Generic Design Assessment – New Civil Reactor Build

Step 4 Internal Hazards Assessment of the Westinghouse AP1000[®] Reactor

Assessment Report: ONR-GDA-AR-11-001

11 November 2011

Figure 1: 3D Computer Model Layout of the Cable Trays Beneath the MCR

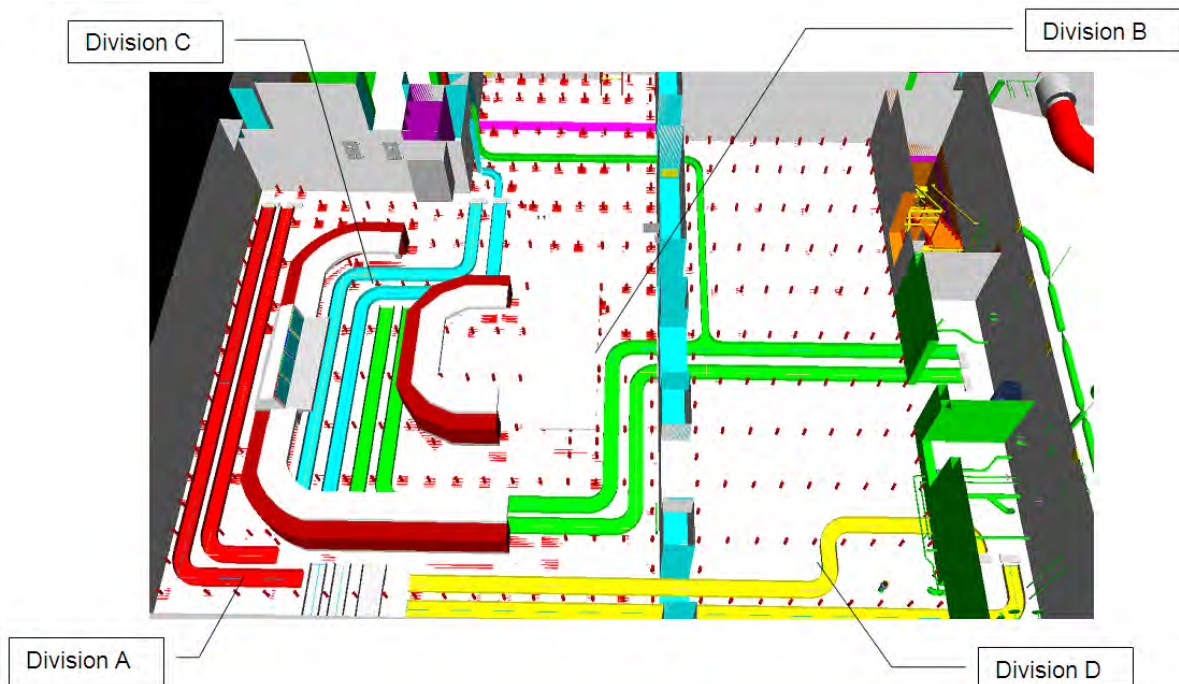
273 There are cables and equipment located within the MCR from all four divisions. The arguments presented within the PCSR include:

- Low fire risk due to limited combustible inventory and use of fibre optic cabling.
- Remote shutdown station contained within a separate 3 hour fire barrier with independent cable routes from SSCs important to safety.
- Isolation of all power within MCR through the use of a transfer switch such that spurious operation of SSCs important to safety is prevented.
- Permanently occupied area by trained personnel.
- Portable fire extinguishing capability.

275 Figure 1, below, illustrates the different divisional routes located beneath the MCR. It is important to note that the cable trays shown beneath the floors comprise the totality of the cable trays and not just the divisional separation groups (due to the use of fibre optics), which is significantly different to the existing UK reactor fleet where cable mezzanines beneath the MCR are generally very high fireload areas protected by fast acting suppression systems. In addition, there is redundancy applied within the design by virtue of the provision of the remote shutdown station, whose divisional separation cable trays do not pass through sub-floor of the MCR. Given the significantly reduced fireload inventory beneath the MCR arising from the use of fibre optic cable coupled with the local fire protection applied to the cable routes as well as the provision of the remote shutdown station where the divisional cables are not routed beneath the sub-floor of the MCR, the risk of fire or any other Internal hazards resulting in loss of more than one division due to failures attributed to the cable routing is ALARP.

Figure 2 – Pipe Rupture Analysis Screenshot from the 3D Model

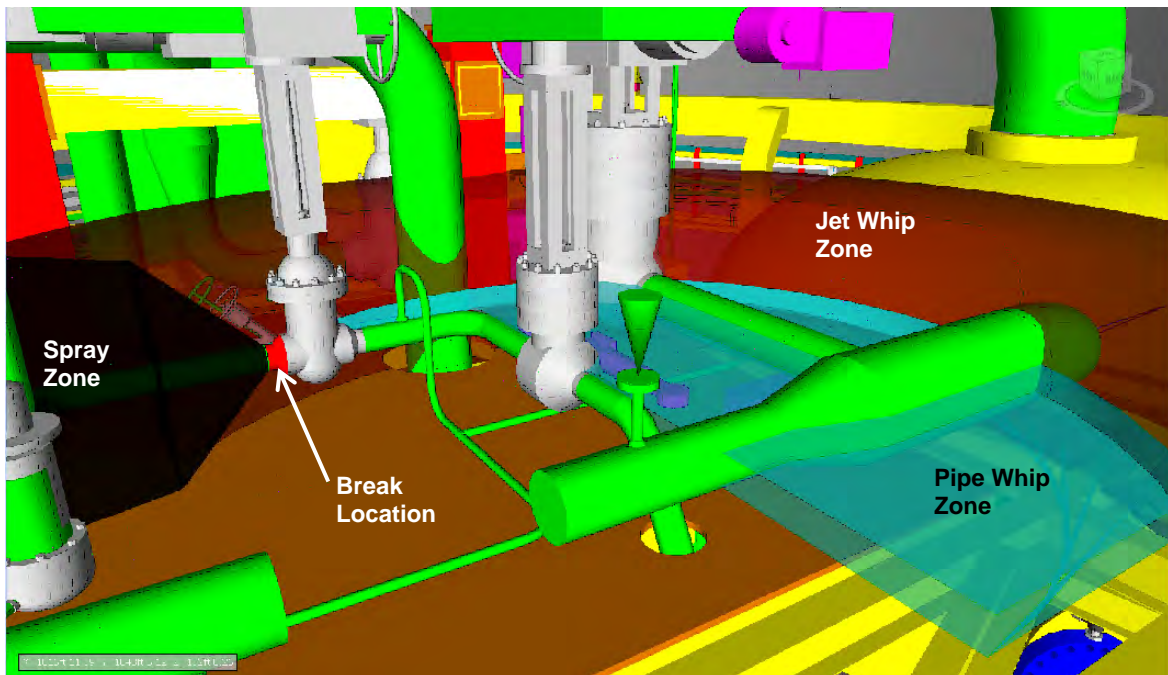
348 TQ-AP1000-1288 was raised seeking further information relating to the Pipe Rupture Hazard Analysis (PRHA) that has been undertaken on the AP1000. The response provided an overview of the detailed pipe rupture analysis undertaken of the AP1000 design and included consideration of:

350 Figure 2 presents part of the analysis undertaken for a break in the Reactor Coolant System. The red segment at the valve is the break, the black cone is the spray zone, blue curve is the pipe whip zone, and the large red arc is the jet whip zone.

351 As can be noted from the screenshot within Figure 2, the analysis considers many factors associated with pipe breaks including potential hinge effects, the consideration of jet impingement and spray effects on safety significant SSCs.
